## Product Change Notification

Product Line:	COMBO A	Part No:	NCJ6FA-*
Piece Part:	XLR contact	Part No:	91418511 91418521 91418531 91418561 91418571
Engineering Change Request:	-	Date:	-
Engineering Change Execution:	-	Date:	-
Comments:	XLR contacts changed to selective plating		
Affected products:	NCJ6FA-H, NCJ6FA-H-0, NCJ6FA-H-0-Y, NCJ6FA-H-D, NCJ6FA-H-Y, NCJ6FA-V, NCJ6FA-V-0, NCJ6FA-V-0-Y		
First Shipment of Modified Product:	H01

### Engineering Change Notice

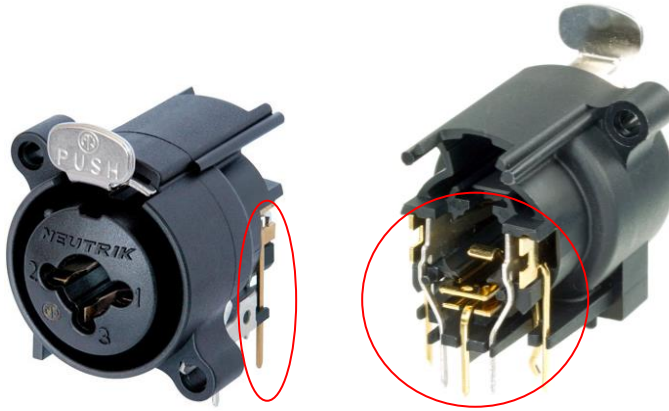
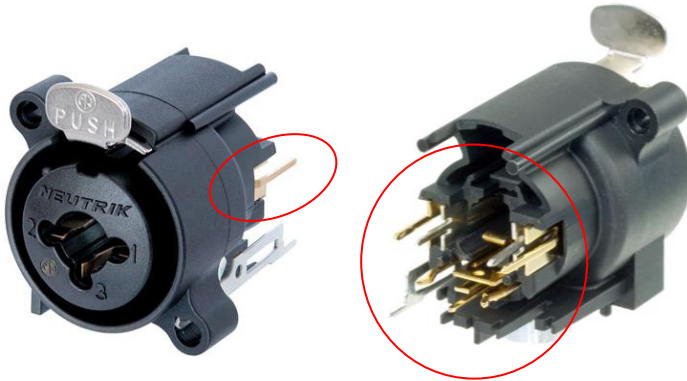
Plating changed from fully gold plated to selective gold plating at contact area and tin plating at PCB termination area for best conductivity and solderability.

XLR contacts  
fully gold plated

XLR contacts  
with gold plating  
at contact area  
and tin plating at  
PCB termination  
area
